Response to Further Information request under Section 92 of the Resource Management Act – (BUN60453058) Queen Street Wastewater Diversion Programme - Mayoral Alignment

Attachment A: Full Response to Request under s92 of the RMA

Section 92 Request for Information: BUN60453058 – Queen Street Wastewater Diversion Programme – Mayoral Alignment			
Item	Information Request	Applicant's Response	Council Response

Figure 2-3: Groundwater level monitoring for piezometers installed for the Mayoral Drive Alignment Project.

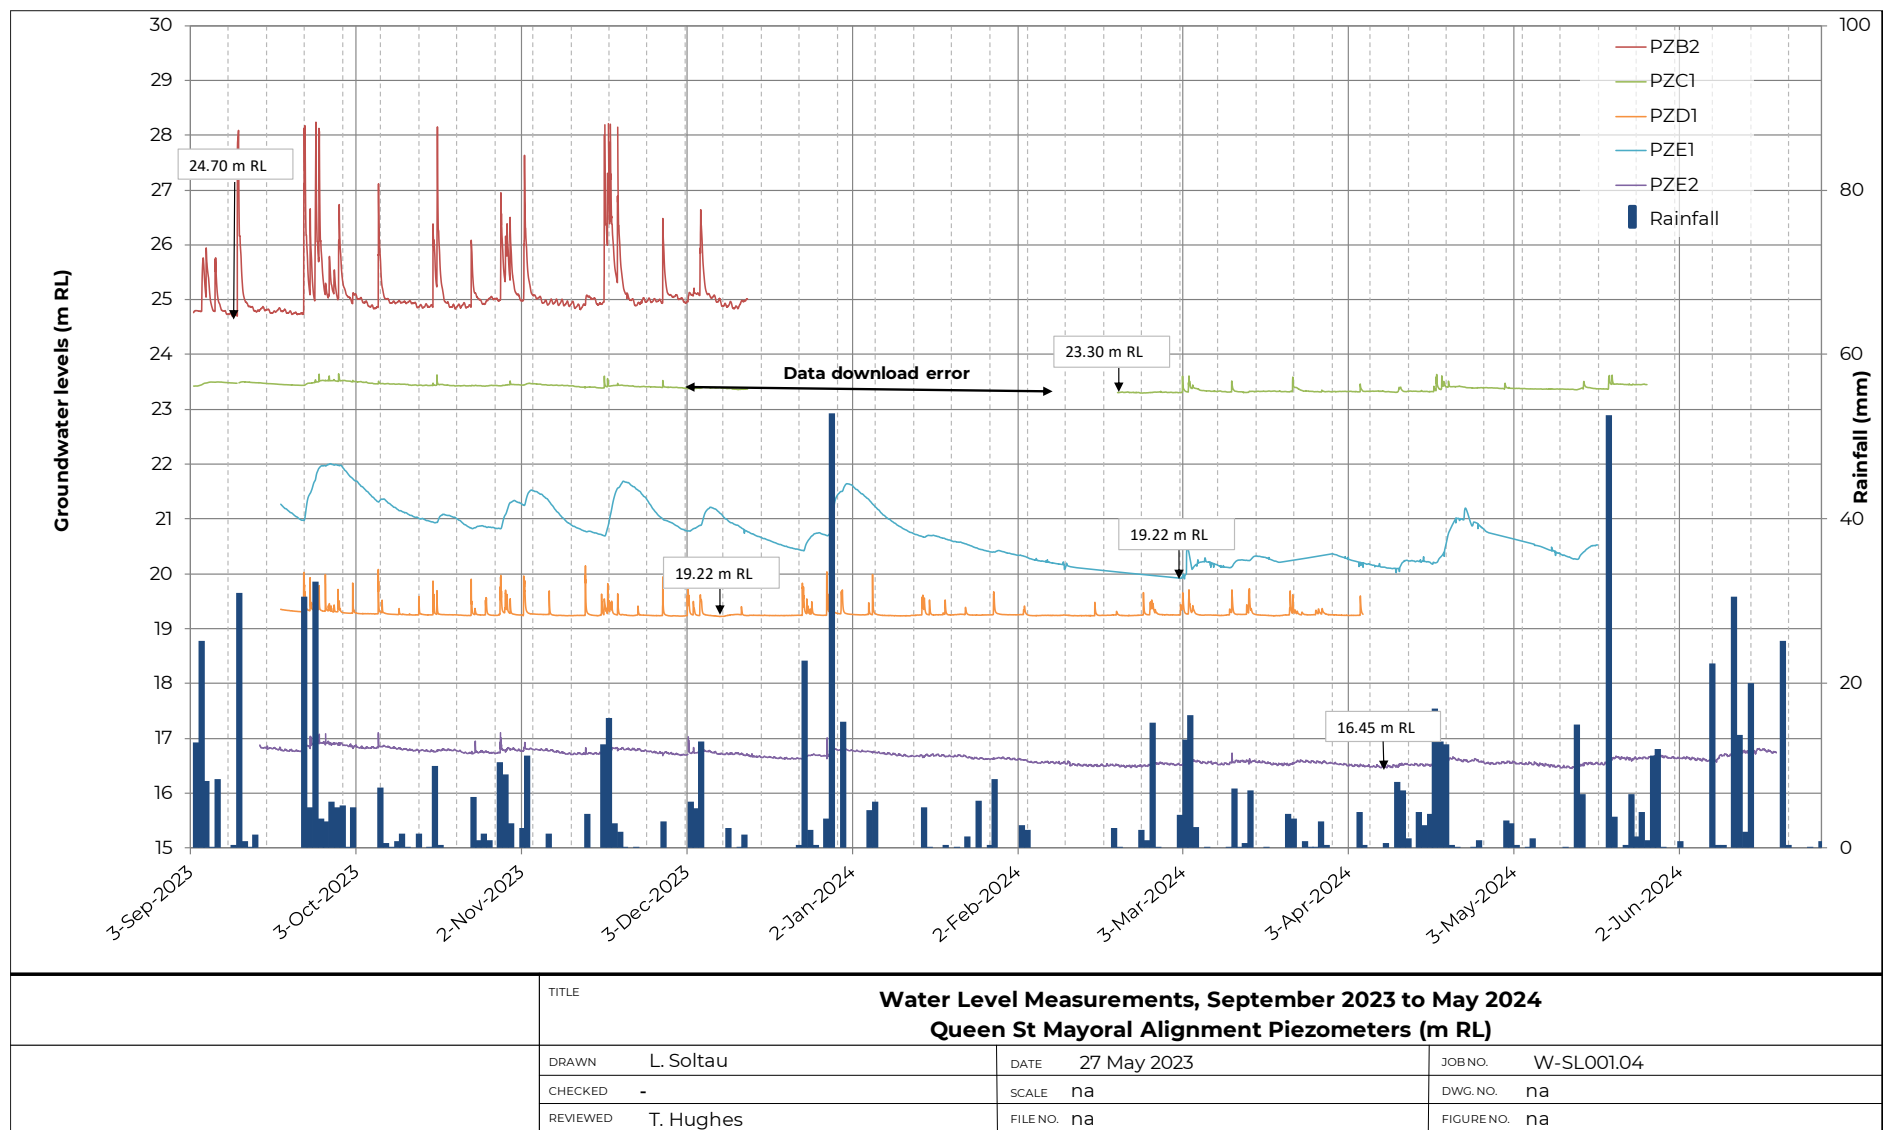
8.	Please annotate Figure 2-3 with the lowest groundwater level measured in each piezometer	Report updated with amended Tables 2-1 and 4-3 demonstrating water levels applied for dewatering

during the monitoring period and update Table 2-1 to include this level for PZB2, PZC1, PZD1, PZE1 and PZE2. In addition, please confirm that the lowest measured groundwater level has been used in the groundwater drawdown analysis and assessment and that the groundwater levels given in the assessment against AUP(OP) Standard E7.6.1.10(4b) in Table 4-3 of the WSP Dewatering Assessment are correct.	modelling. An explanation as to what was adopted at the shaft location is presented in Section 5.3.2

Figure 6-1: High K estimate case groundwater drawdown for the P4MH3 Shaft.

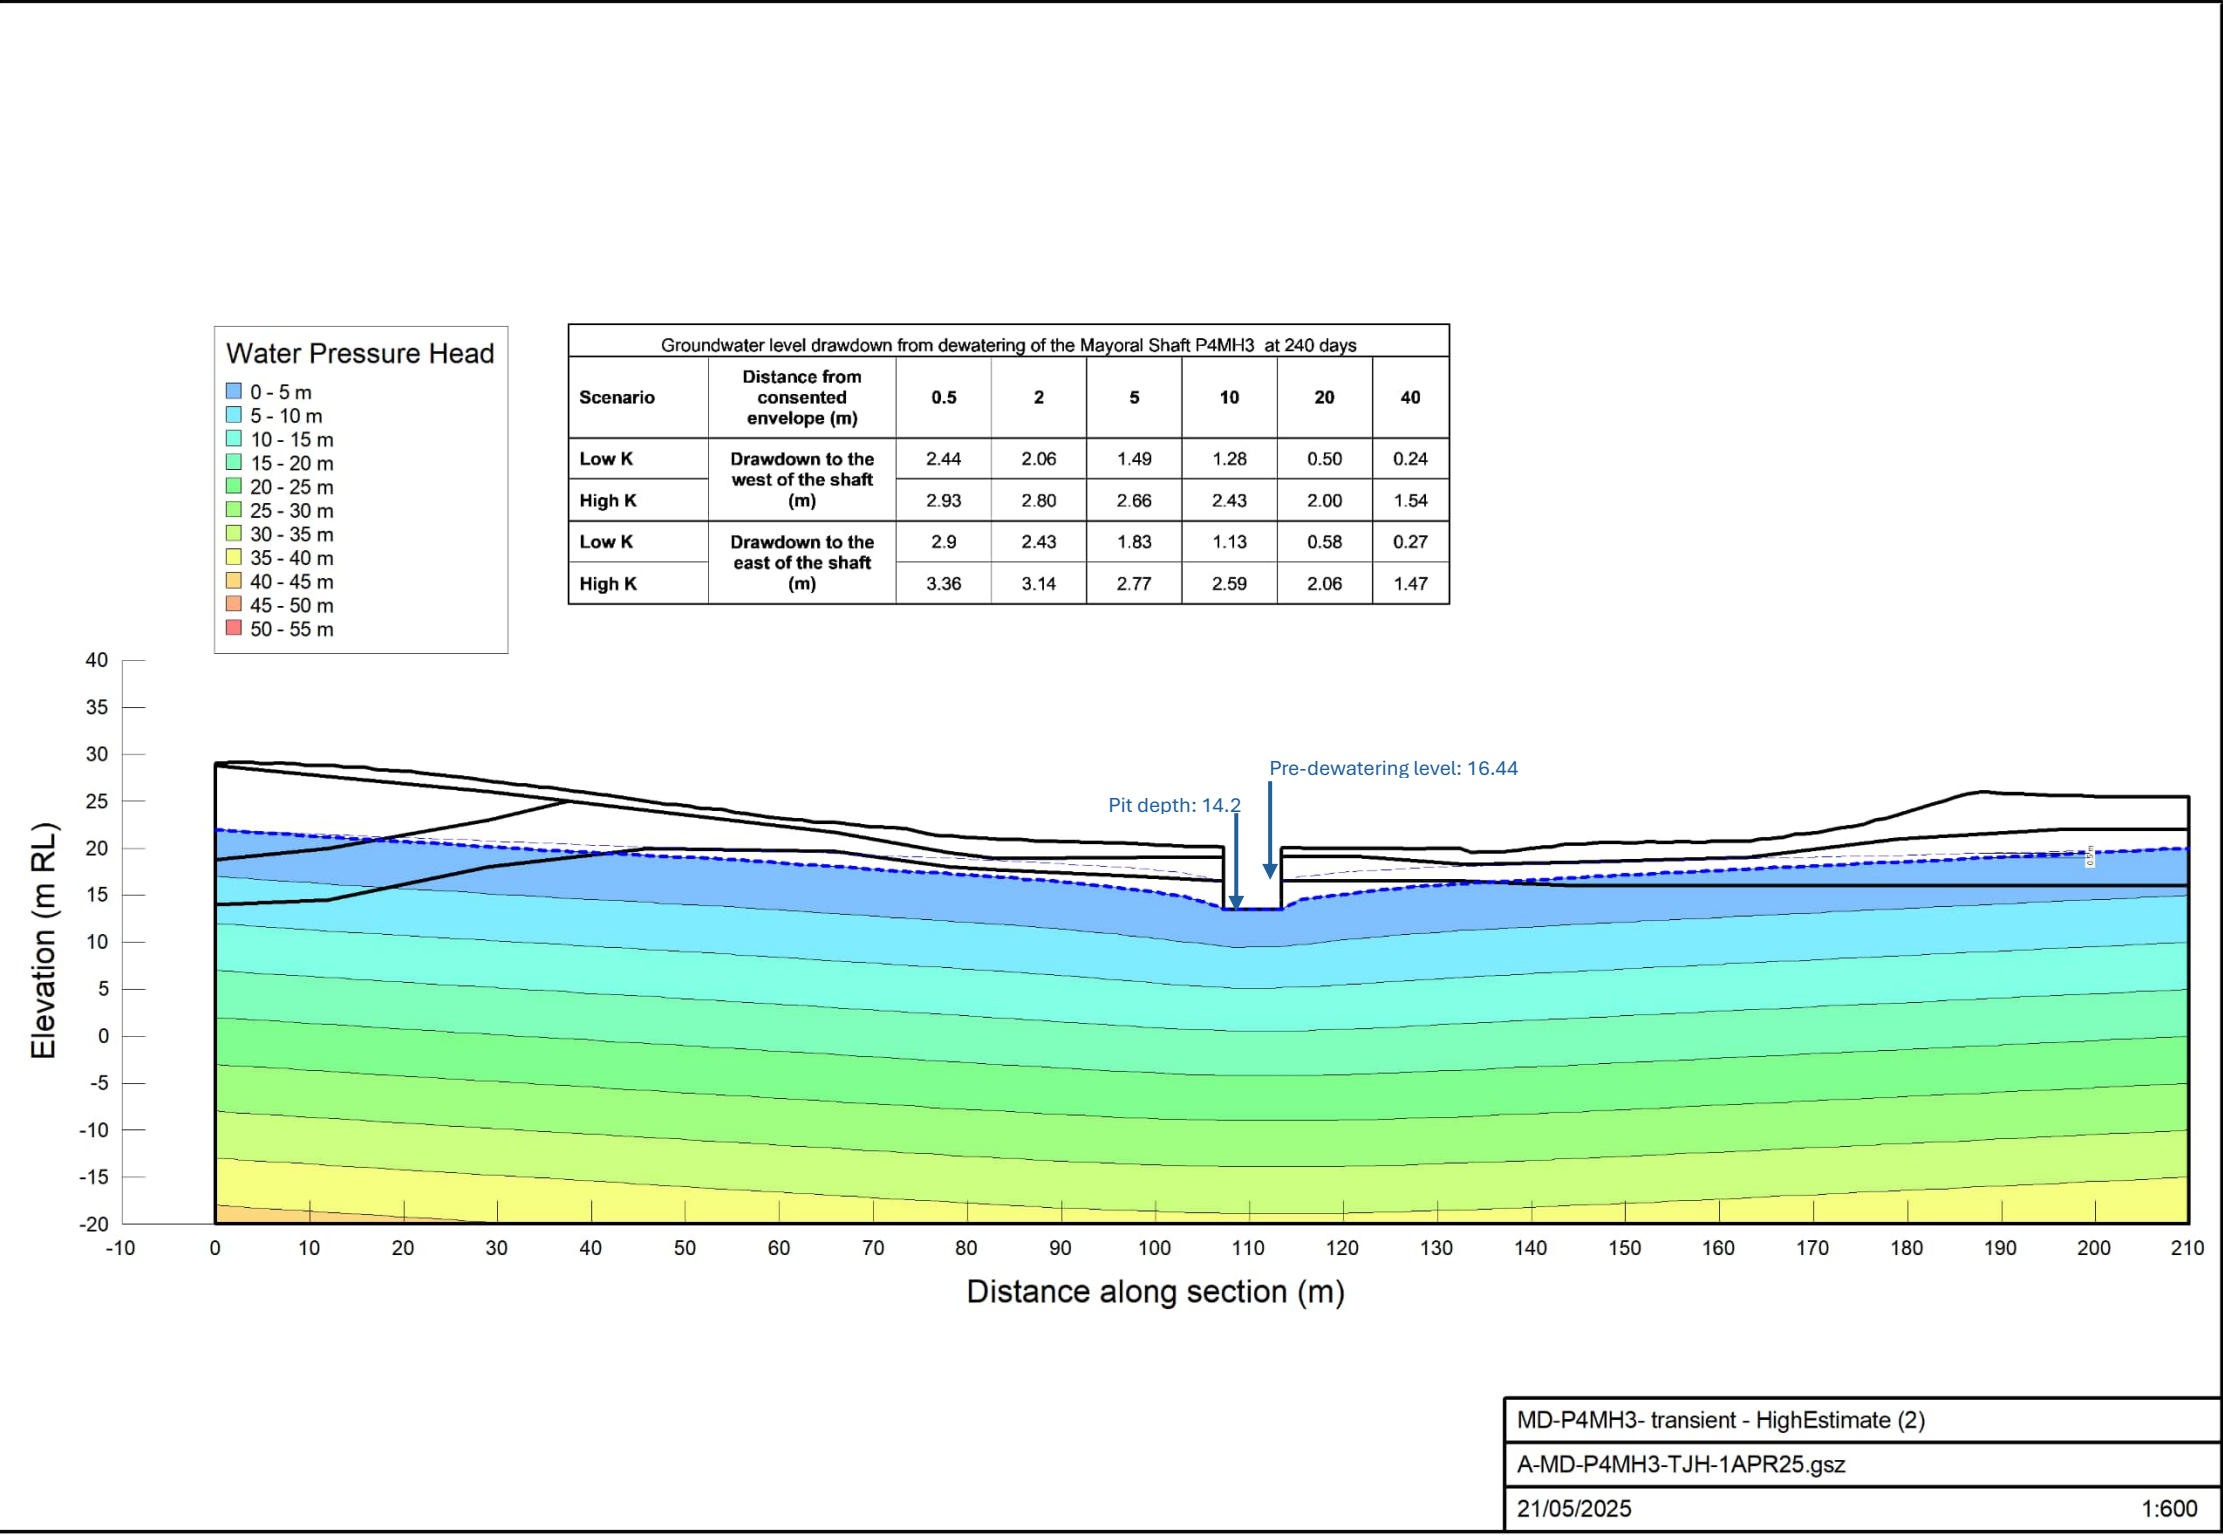
22.	Post- AC meeting request (6/8/25) I noticed that the consolidation settlement profile – blue line on Figure 6-1 appears to show less settlement (approx. 2mm) at the proposed shaft P4MH3 and more settlement (approx 5mm) at 25m - see attached mark up It could be reasonably expected that there would be greater groundwater drawdown at a shaft and hence greater consolidation settlement at the shaft. This contrasts with the consolidation settlement profile – blue line on Figure 6-3 which shows more settlement (approx. 25mm) at proposed shaft P4MH2 and less settlement approx. 5mm at 80m – see attached mark-up. Please provide an explanation as to why Figure 6-1 indicates that there is greater consolidation settlement at a distance of 25m from shaft P4MH2 than at the shaft.	In Figure 6-1, the higher dewatering settlement away from the shaft is related to the stratigraphy and the initial groundwater conditions: the only practically compressible layer that experiences dewatering is the residual soil. There is more dewatering predicted in the residual soils away from shaft rather than close to it, which results in higher dewatering settlement at some distance from the shaft. The answer to the differences in the consolidation settlement is provided above.

Please prove an explanation as to why the mechanical settlement and consolidation settlement profiles Figure 6-1 & 6-3 are so different for P4MH3 & PH4M2.		
--	---	--	--
